Seaton Trail - Friends Walkthrough and Survey –May 8, 2010

Survey was complied by Gary Ataman and Gord England on May 8, 2010.

N43.871327, W79.132998

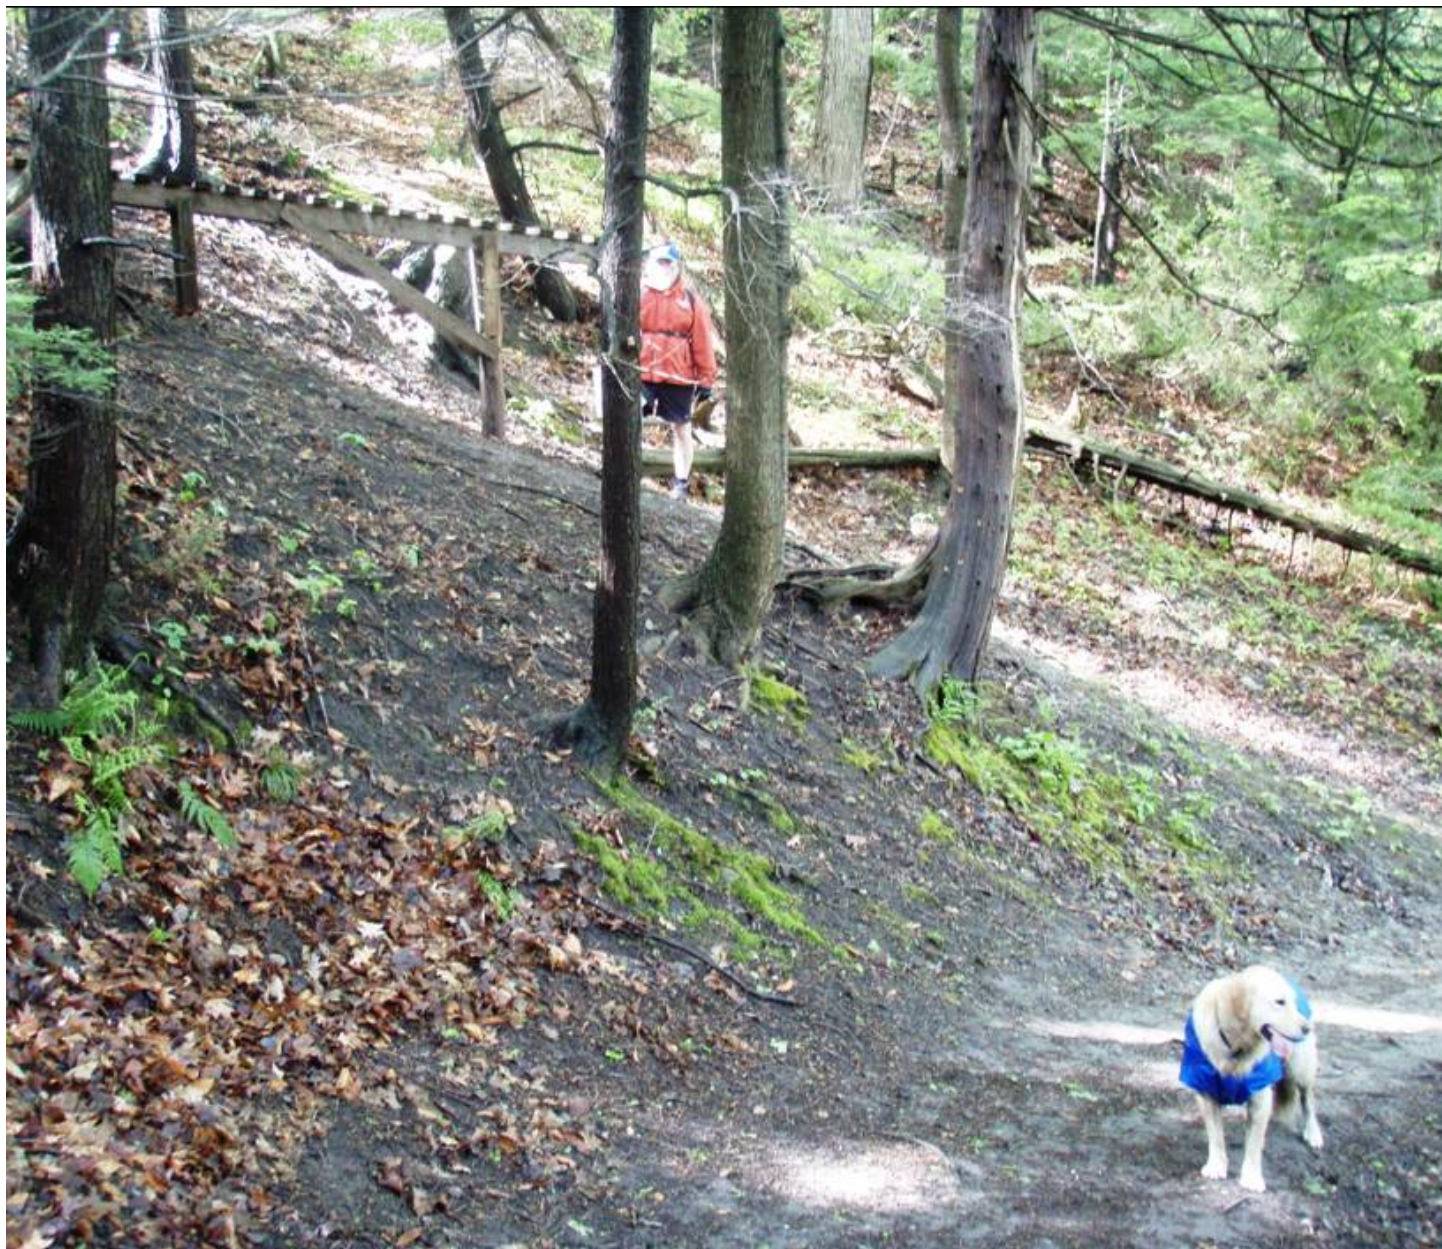
Garbage on side of Forestream Trail/ Old Whites Road bridge.
Need to get town to clean up area

Need to post NO DUMPING SIGNS

2N123

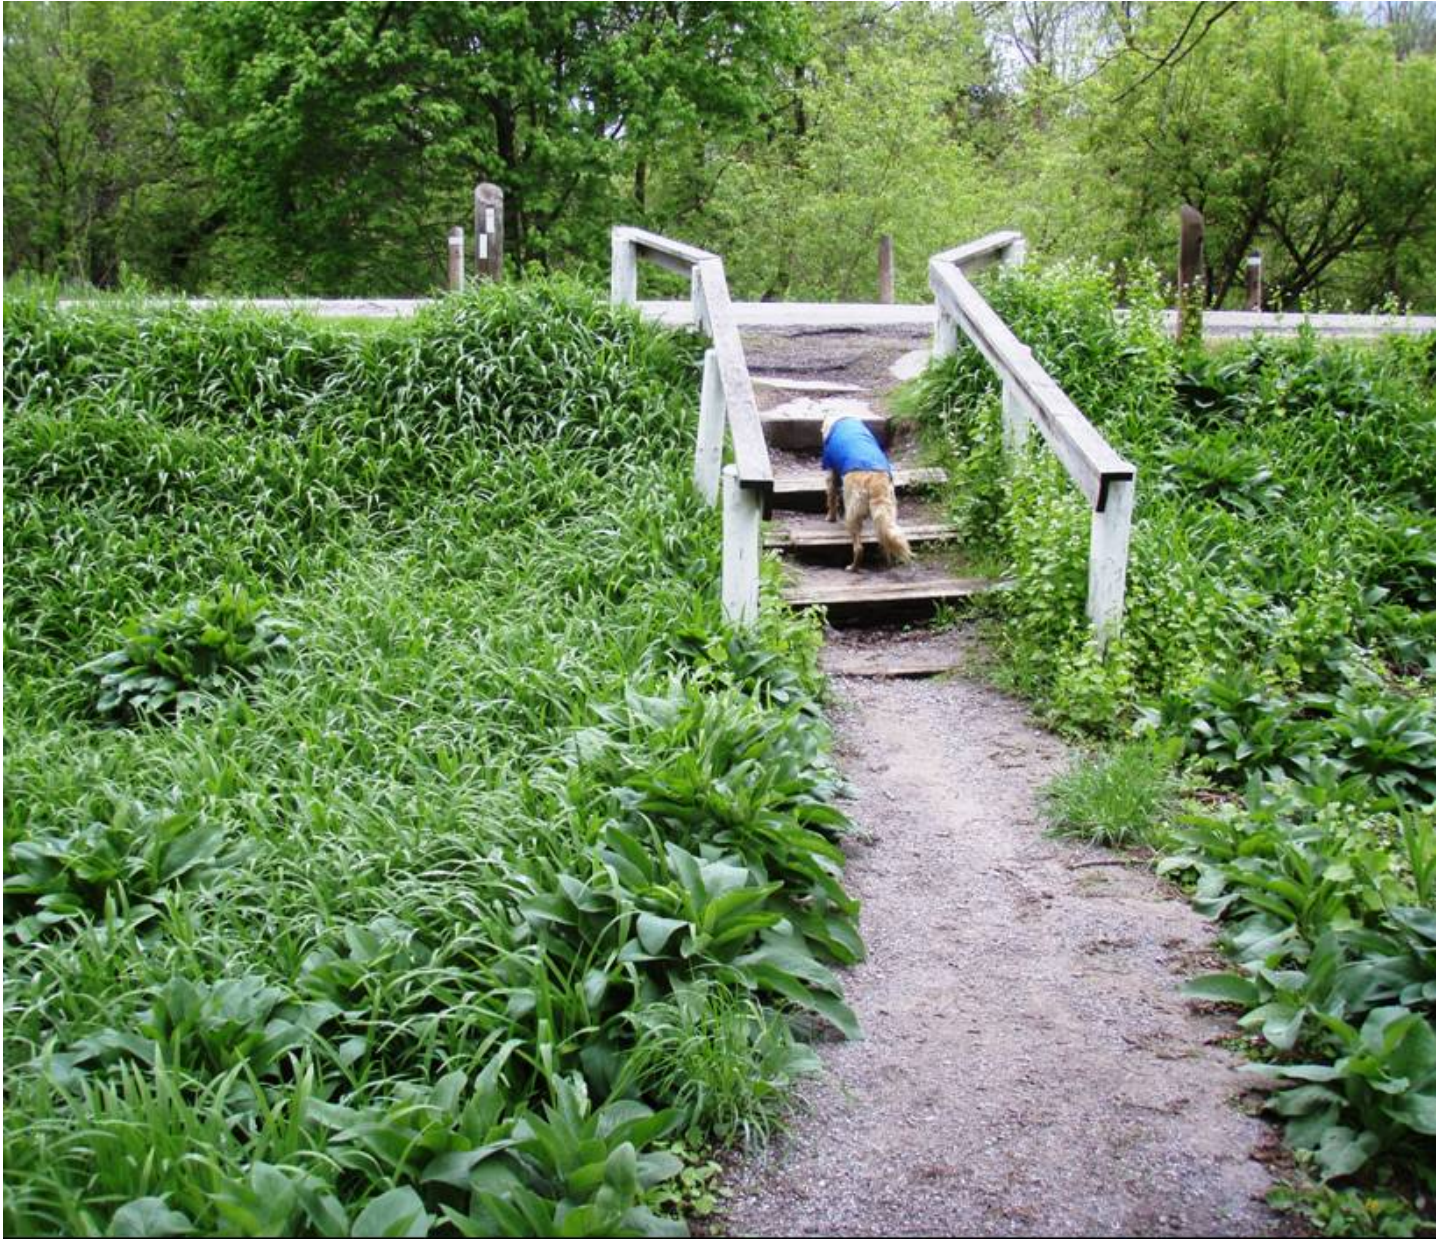
Bridge into Whitevale park needs to be position better and boards added to both ends to make a strong at corner edge. The bridge should be longer and transition into trail better.
